## **AMENDMENTS TO THE DRAWINGS:**

## **REMARKS**

Serial No. 10/734,214 In re Office Action dated February 10, 2006 Amendment dated May 10, 2006

Fig. 1

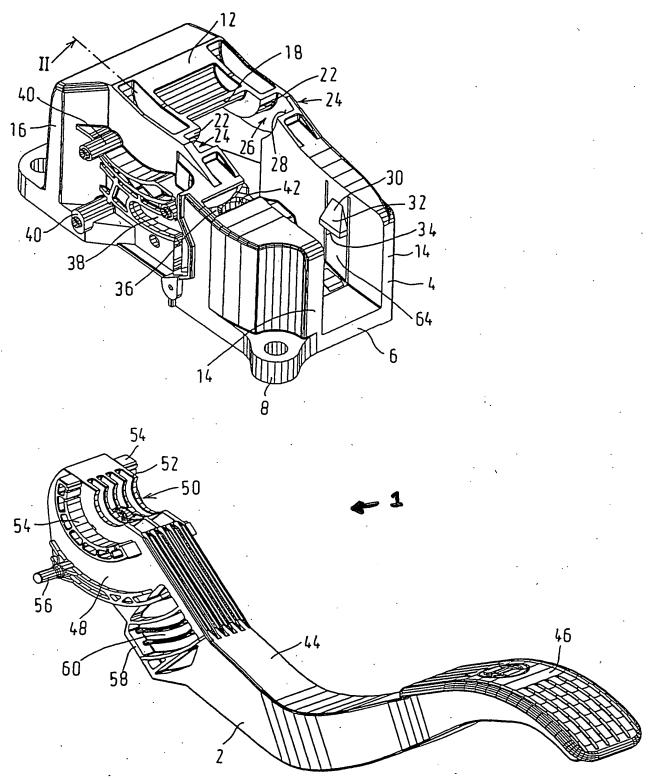
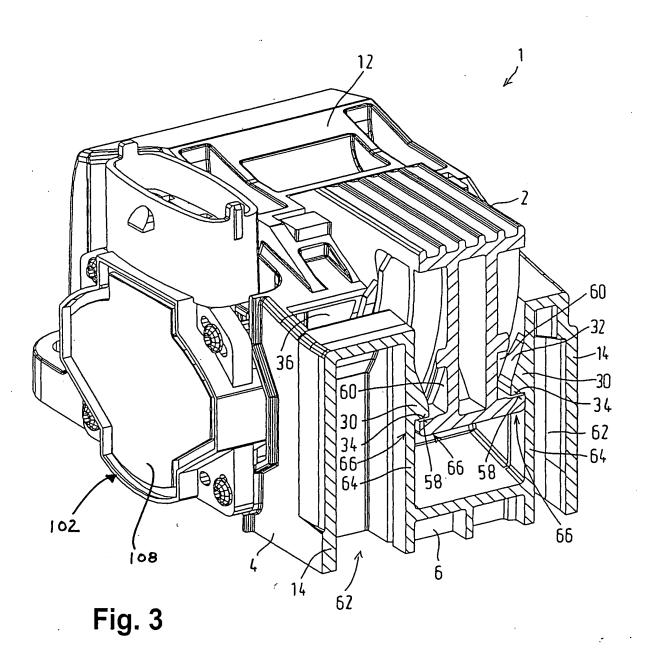
The examiner has objected to the drawings as failing to comply with 37 CFR 1.84(p)(5) because they are missing the following reference numerals: reference numeral 1 is missing from Fig. 1; reference numeral 30 is missing from Fig. 2; and reference numeral 90 is missing from Fig. 7. Substitute sheets of drawing are included in this amendment incorporating the required changes. With regard to reference numeral 30 missing from Fig. 2, the specification has been amended to clarify that reference numeral 30 is shown in Fig. 1.

The attached sheets of drawings include changes to Figs 1, 3, and 7. These sheets replace the original sheets of Figs. 1, 3, and 7. In Fig. 1, previously omitted reference numeral 1 has been added. In Fig. 3 previously omitted reference numerals 102 and 108 have been added. In Fig. 7, previously omitted reference numeral 90 has been added.
